**MANDATORY BULLETIN No. Harmony LSA-019a SR
SAFETY RELATED**

| 1. CONCERNING: | All Harmony LSA airplanes equipped with the ROTAX 912 iS series engine. |
| 2. REASON: | Unification of the strength class of the fastening bolts in the joint of the engine and the engine mount hinges and the resulting minimization of the possibility that these bolts will be accidentally interchanged. |

Fig. 2 – Engine mount – position of fastening bolts

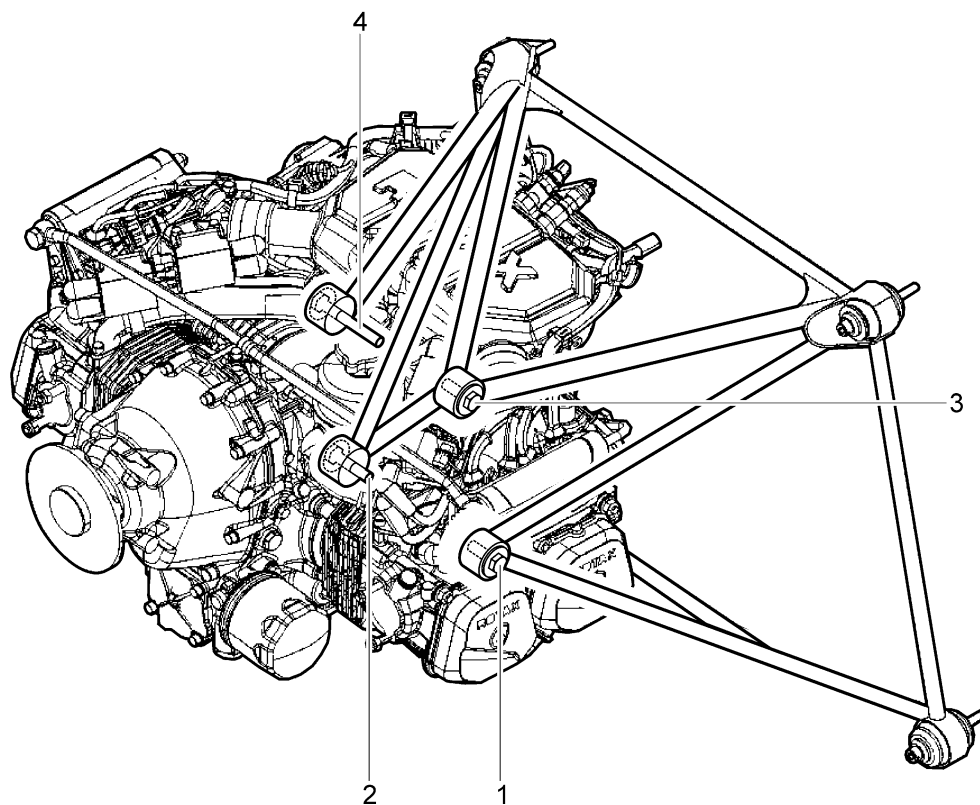
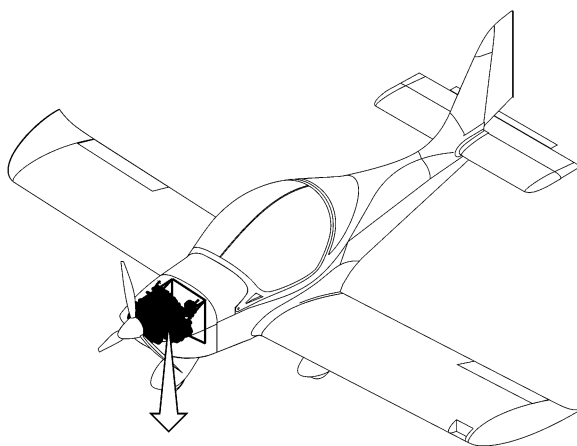
- 1.3.1.11 Remove the bolt (1) from the joint of the engine and the engine mount hinges. Immediately replace the removed bolt with a new one and tighten it slightly.

- 1.3.1.12 Remove the bolt (2) from the joint of the engine and the engine mount hinges. Immediately replace the removed bolt with a new one and tighten it slightly.

- 1.3.1.13 Remove the bolt (3) from the joint of the engine and the engine mount hinges. Immediately replace the removed bolt with a new one and tighten it slightly.

- 1.3.1.14 Tighten the bolt (4) in the joint of the engine and the engine mount hinges using a torque wrench with a torque of 40 Nm. This bolt is the only one that is not replaced, but the tightening torque value is changed from 35 Nm to 40 Nm.

- 1.3.1.15 Tighten the bolts (1,2,3) in the joint of the engine and the engine mount hinges using a torque wrench with a torque of 40Nm.
- 1.3.1.16 Put the plugs (5, Fig.3) on the bolts (4), (1,2,3,4, Fig.2).

*Fig. 3 – Engine suspension*

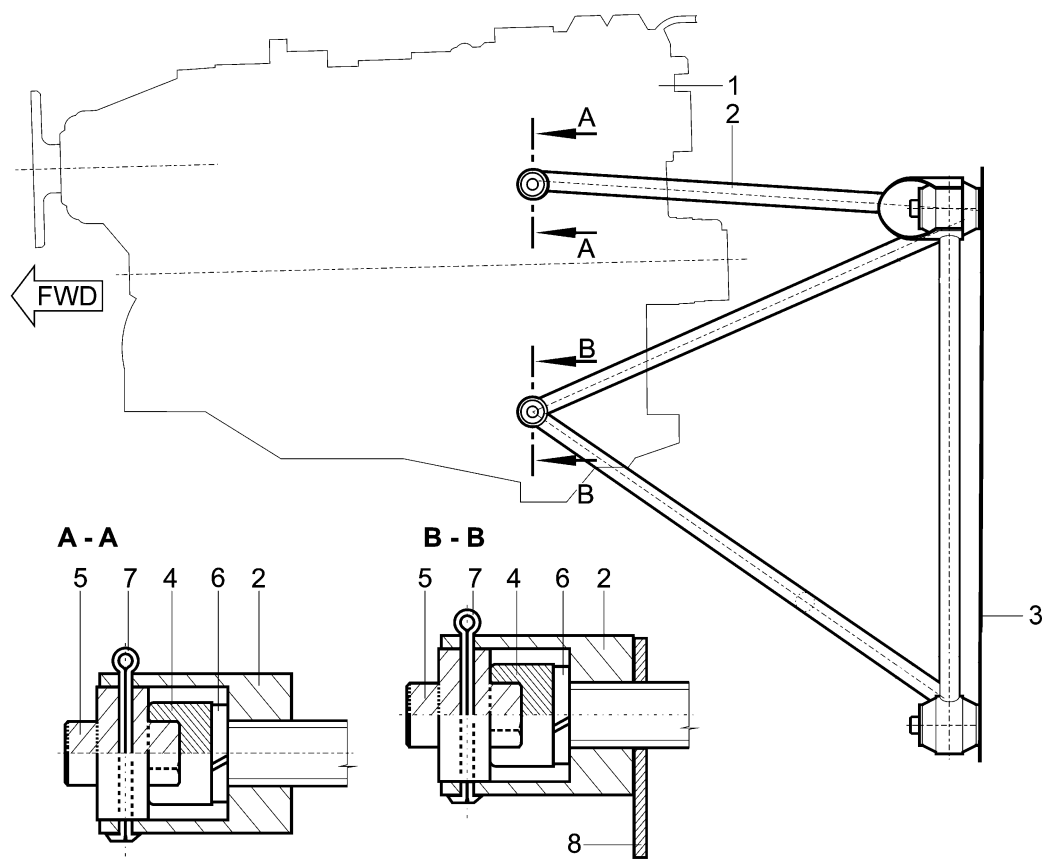
- 1.3.1.8 Secure the ends of the removed hoses with suitable plugs against the ingress of dirt.
- 1.3.1.9 Hang the engine (3, Fig. 1) on the workshop crane (1) using the suspension strap (2). The engine (3) is now secured against falling.
- 1.3.1.10 Remove the cotter pins and plugs (5, 7, Fig. 3) from the bolts (1, 2, 3, 4, Fig. 2) in the joint of the engine and the engine mount hinges.

- 1.3.1.17 Mark the plugs (5, Fig. 3) with a marking pin in accordance with the holes in the engine mount hinges (2) on both sides.
- 1.3.1.18 Remove the plugs (5) from the bolts (4) and drill through them with a $\varnothing 2,1$ mm drill bit in accordance with the marks made by the marking pin.

- 1.3.1.19 Put the plugs (5) back on the bolts (4) so that they align with the holes in the engine mount hinges (2).
- 1.3.1.20 Use the cotter pins (7) to secure the bolts (4) with the plugs (5) in the joint of the engine and the engine mount hinges (2).
